**Re: Metal Bank Cottman Avenue NPL Site
Monthly Report due June 10, 2013
Reporting Period: May 1 through May 31, 2013**

Project Name: Metal Bank NPL Site	For the Month: May 2013	
Project Location: Philadelphia, PA	Report Number: 86	Dated: June 10, 2013

Re: Report
Sheet Pile Wall Inspection
Metal Bank NPL Site
7301 Milnor Street
Philadelphia, PA 19136

Figure 1

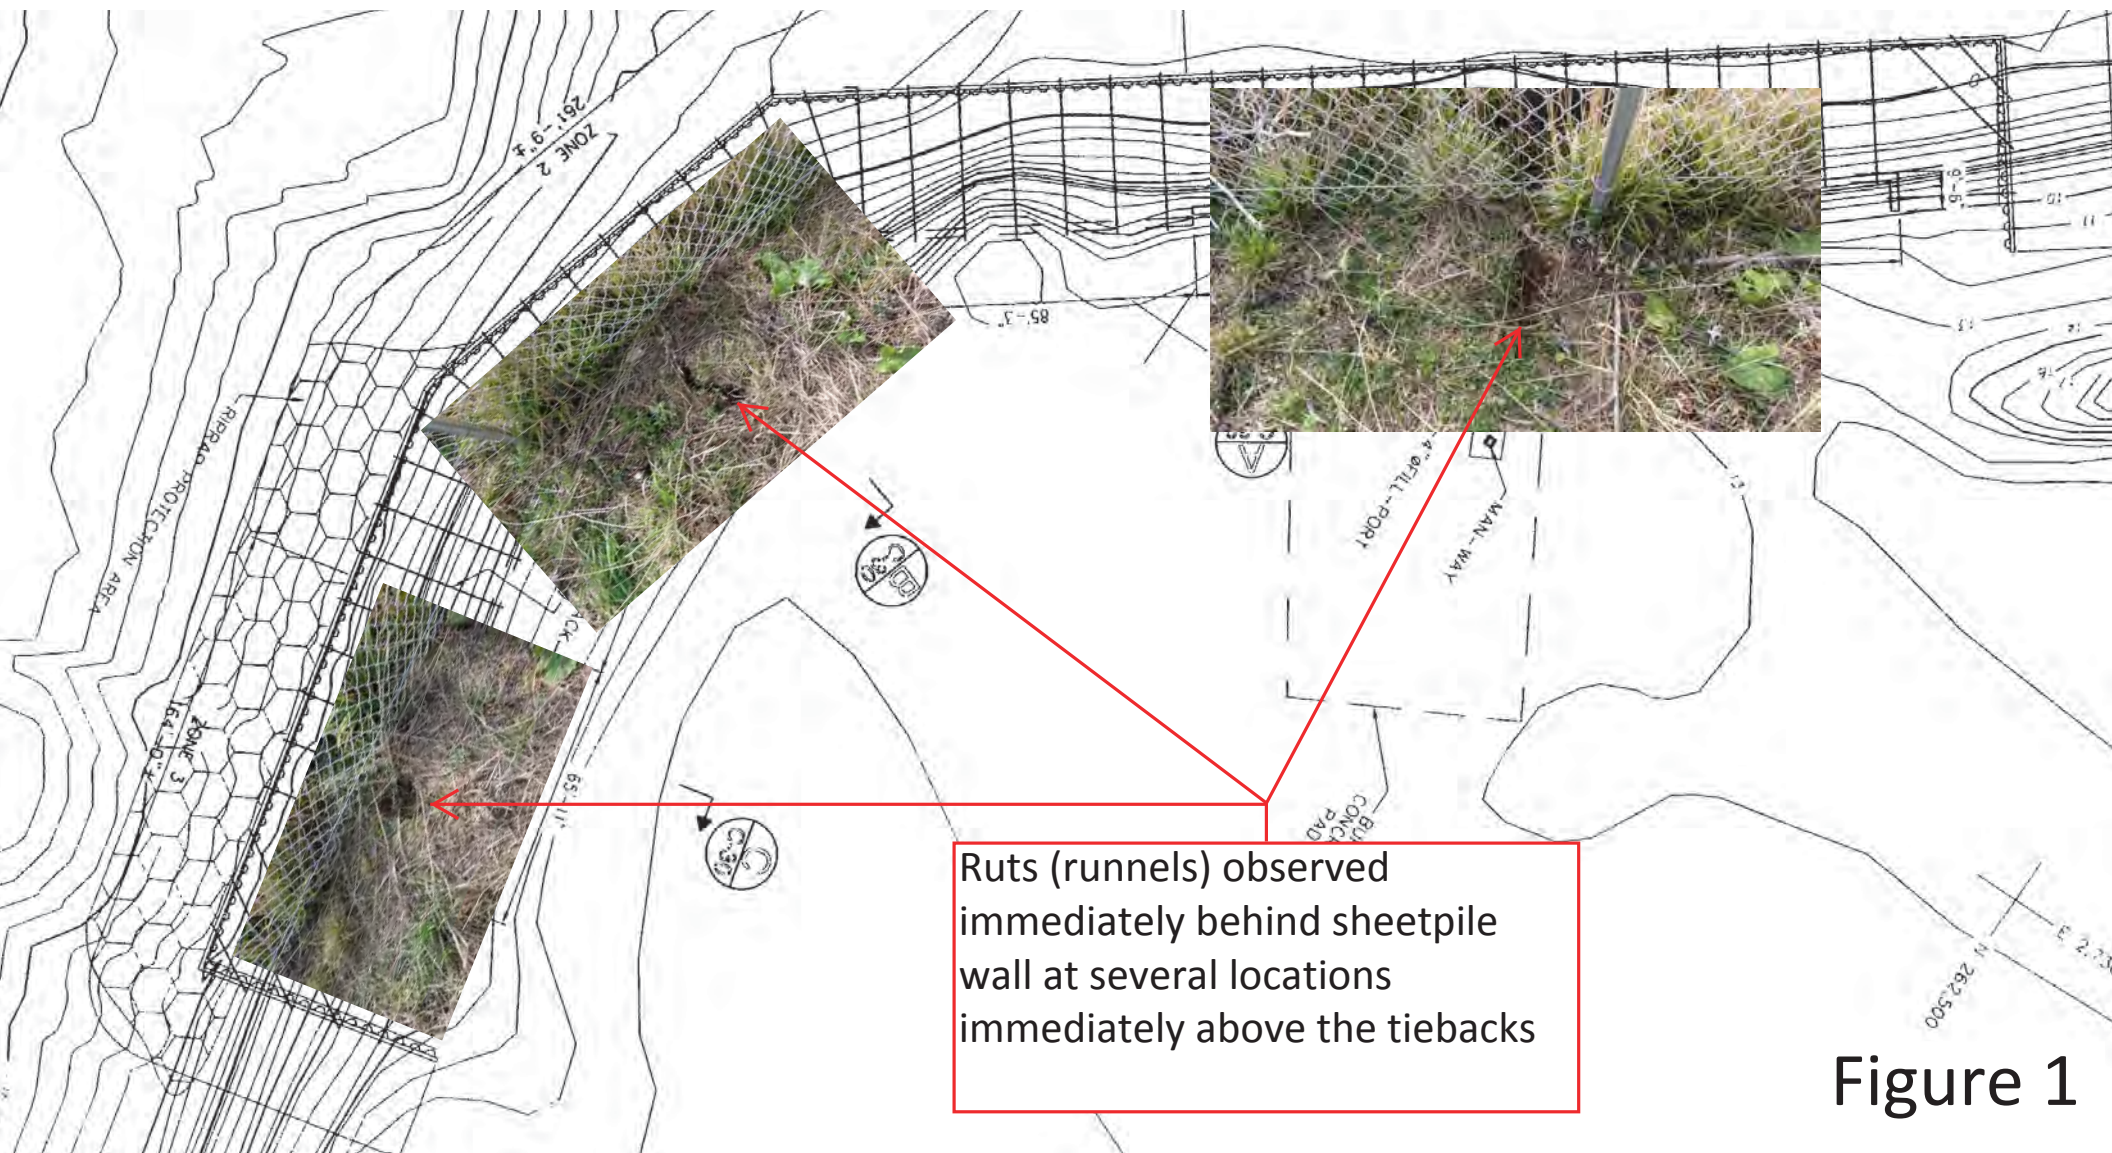
1. Small ruts (runnels) were observed in a few locations immediately behind the sheetpile wall on the landside above the tieback locations as shown on Figure 1. There is no evidence of soil migrating through the sheets at these locations.

1. The sheetpile wall sections show the tiebacks were installed through a 10-in diameter PVC sleeve pipe. The ruts may be attributed to:
 - a. Migration of soil into the PVC sleeve.
 - b. Difficulties compacting around the pile during placement of the fill.
 - c. Lateral movement of the sheet (waterside) creating voids or loosening of the soil around the PVC pipe.
 - d. Water flow in and around the PVC pipe.

In our opinion the few small ruts are inconsequential, nevertheless, we recommend filling the ruts to minimize migration of storm water runoff channeling below grade. Local excavations should be made immediately adjacent to the ruts about 1-ft depth below existing site grade. The ruts and local excavation should be filled and compacted in 6-in lifts with “jumping jack” or walk behind vibratory plate compactor until grade is level. The fill soil should comply with the original project specifications. Replace vegetation in kind.

Figure 2

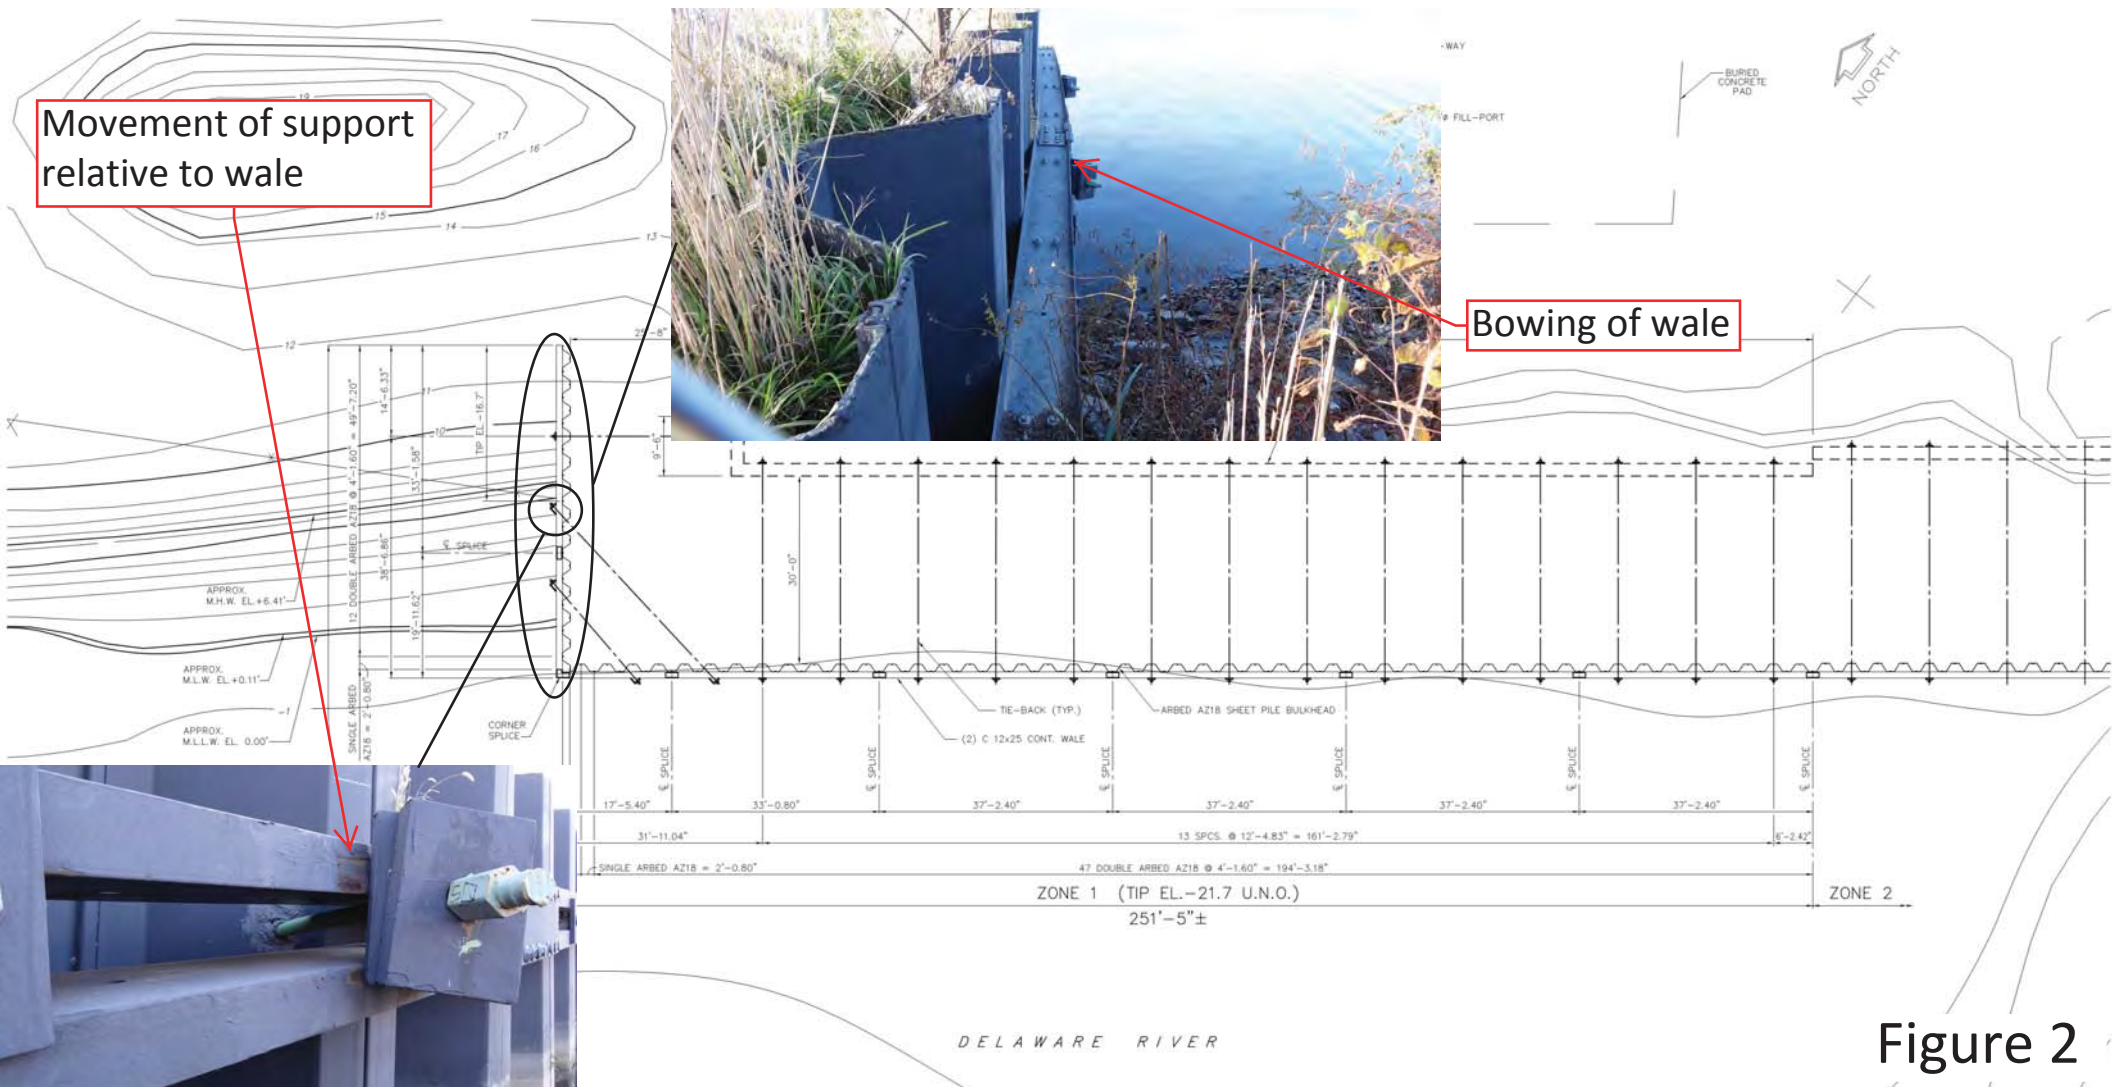
3. The north side of Zone 1 shows movement of the sheetpile wall system. Evidence of movement of the tieback plates relative to the wale was observed by scraping and removal of the epoxy coating on the face of the wale. In addition, the wale and sheetpile wall appear to be bowing with the apex of the bow at the bolted connection. Refer to Figure 2 for location and photographs.

Movement of support
relative to wale

Bowing of wale

Figure 3

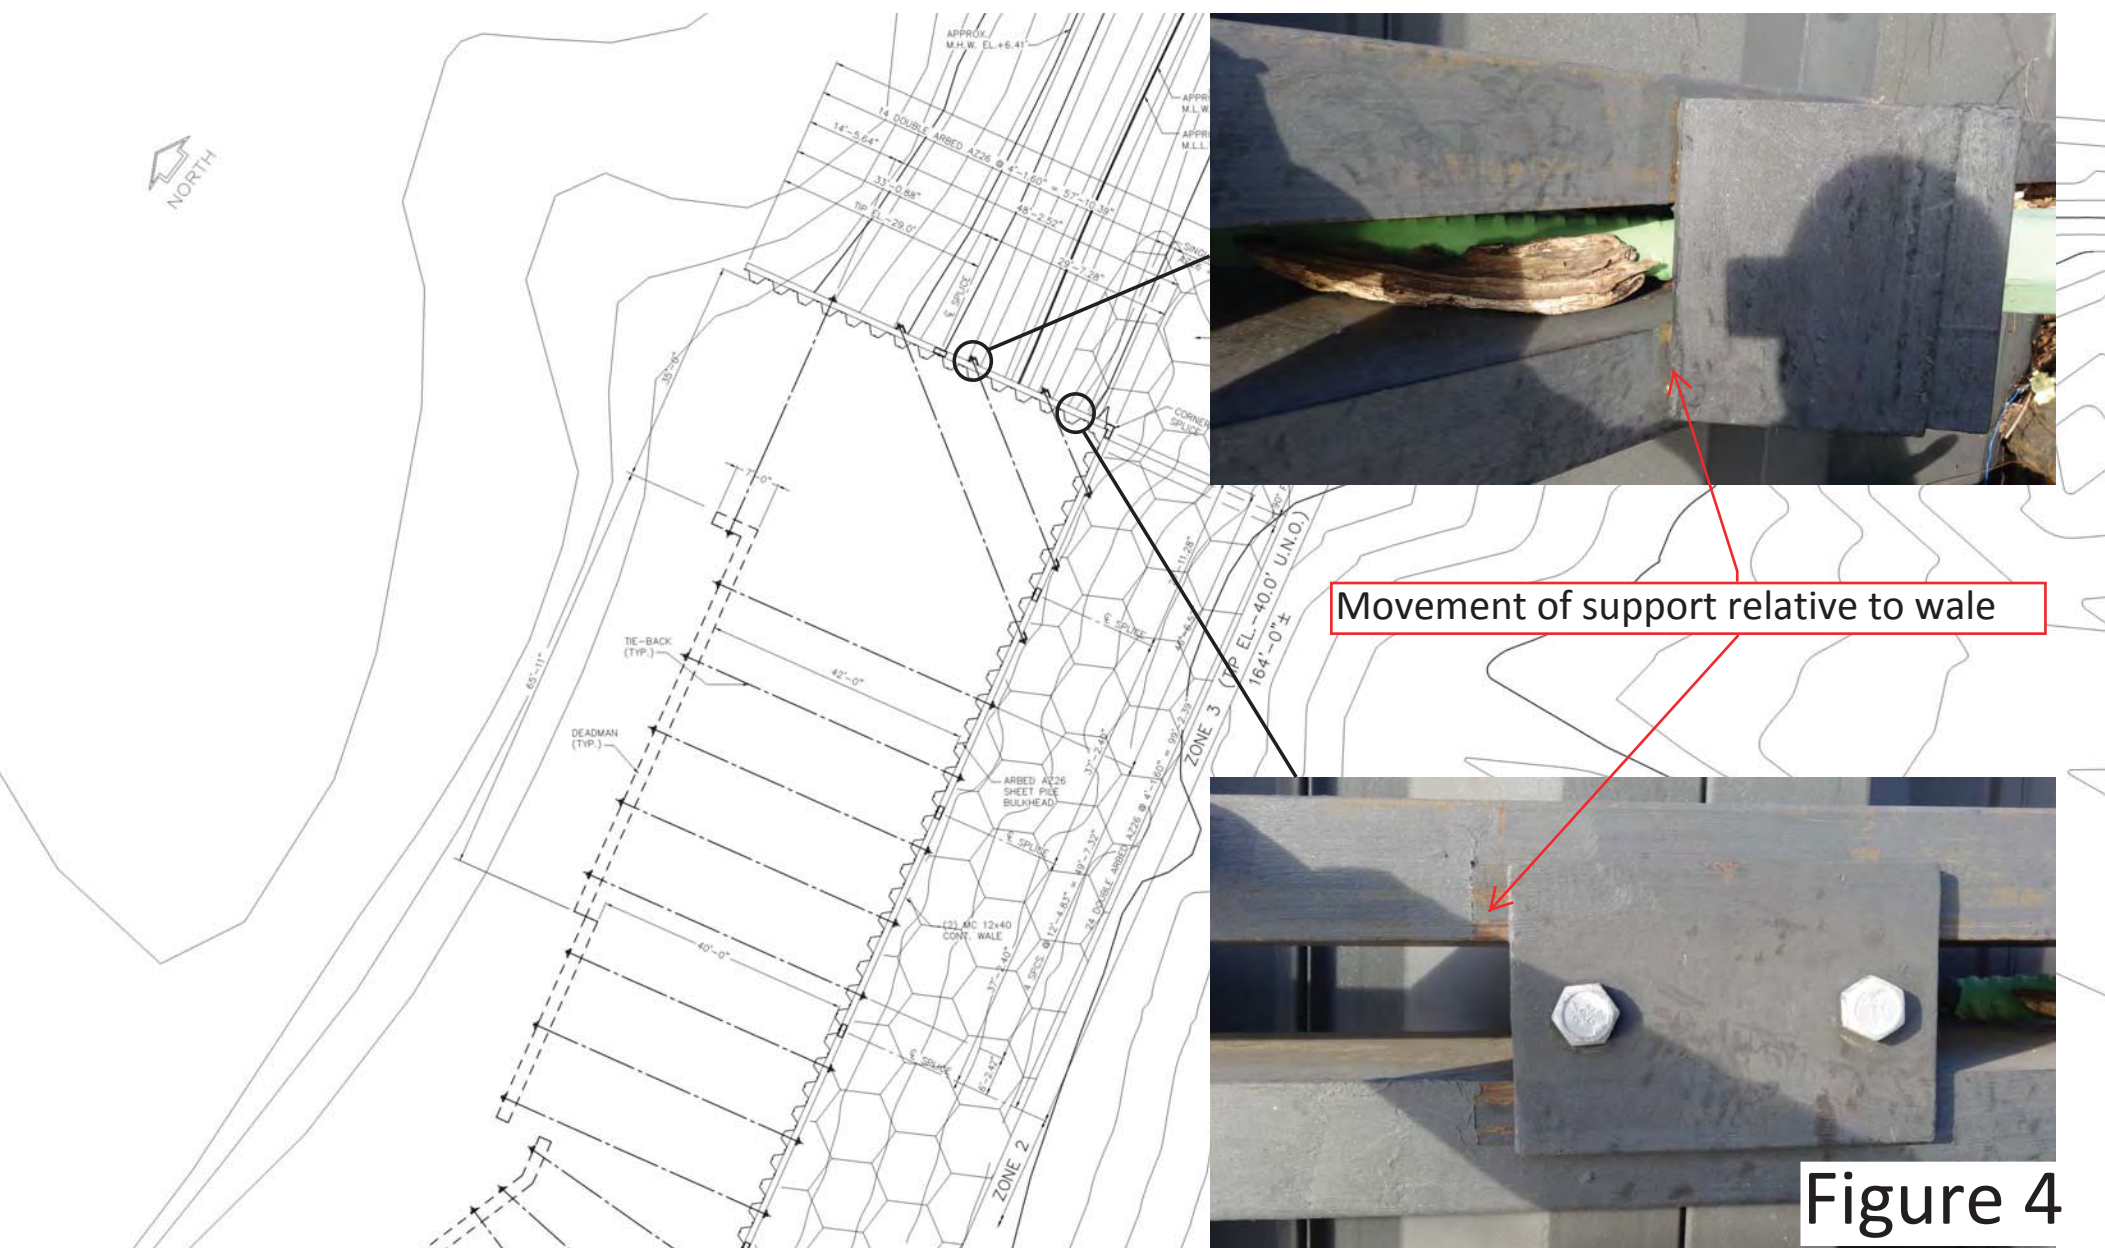
4. Cracks and separation of the wale were observed where the sheetpile wall changes direction (turns east) in Zone 2. The miter cut and joint where the wales meet at the corner was cracked. The cracks appear to be stress (tension) cracks. Refer to Figure 3 for location and photographs. We understand that this area was previously repaired.

perpendicular to the plane of the sheetpile wall. Based on visual observations in other areas of the site, the sheetpile wall has moved (translated) laterally. This will tend to separate or “pull” the corner joint of the wale, resulting in cracks of the weld and steel. We recommend repairing the wale by:

- a. Remove epoxy coating and prepare wale to accept steel plate.
- b. Cut and install steel plate as shown on sketch presented in Appendix B.
- c. Areas adjacent to the corner that are cracked shall receive a steel plate placed within the upper wale flange and on top of the bottom wale web.
- d. Apply epoxy sealant in accordance with the original contract specifications.

The repair of the corner wale as discussed in item 4 should be periodically inspected for signs of movement, distress or cracking. If this problem persists a corrective action plan should be submitted for EPA approval.

Figure 5

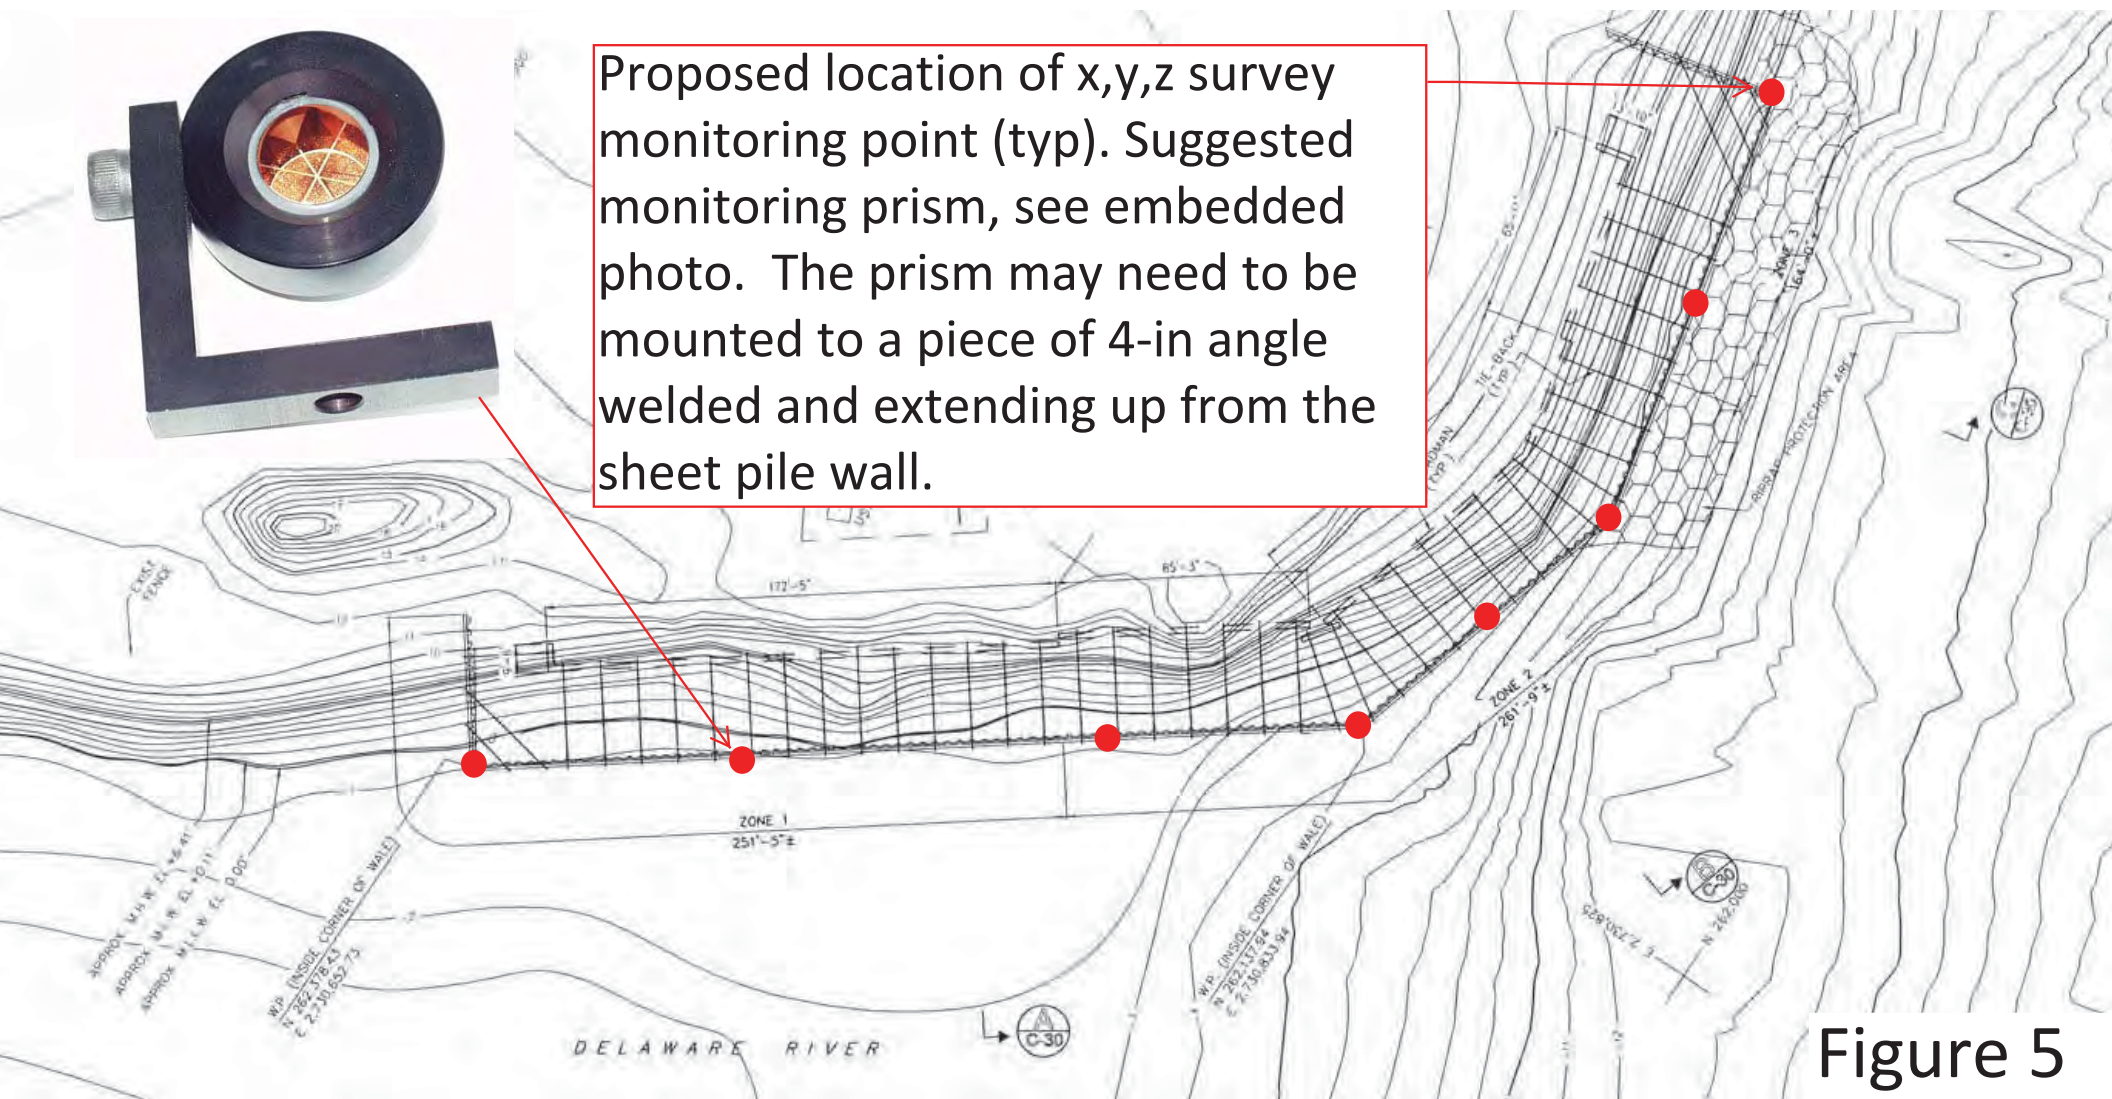
Three tilt meters have been installed on the sheetpiles to monitor their movement. The tilt monitors have the capacity to measure tilt (rotation) of the sheetpile but not translation.

We recommend installing monitoring points (prisms) on the top of the sheetpile wall to monitor potential movements in the x, y, and z coordinates. Proposed location of the survey monitoring points are presented on Figure 5. The monitoring points should be surveyed once every 6-months and the data reviewed by an experienced engineer. If a trend of wall movement is observed, the frequency of the survey should be increased and the sheetpile wall re-evaluated.
